# la marzocco USA technical bulletin 195

**Linea Classic S new “tall cups” version.**

**June 14, 2024**

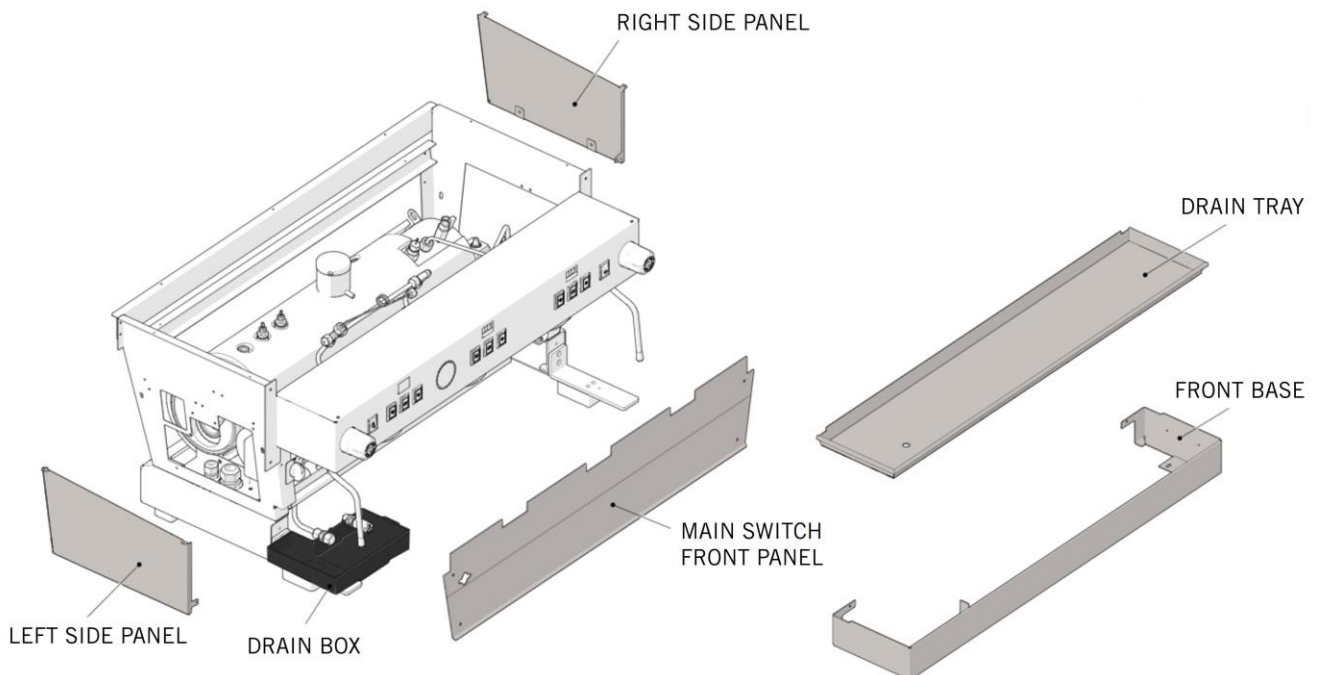
We have recently modified 2,3, and 4 group Linea Classic S to accommodate taller cups.

The change consists in lowering the drain tray by 11mm.

This has also required modifying all components that are indicated in the picture below.

To also facilitate the removal and assembly of the front base, the screw and nut that secure its back side to the machine's frame have been replaced by studs (welded on the panel) and wingnuts.

Retrofitting older machines to the new version, or vice-versa, isn't suggested, and it's only possible by replacing all "high cups" components (see picture above).

All Linea Classic S starting from the following serial numbers are updated with "high cups" components:

2gr: LS013923

3gr: LS013921

4gr: LS014953
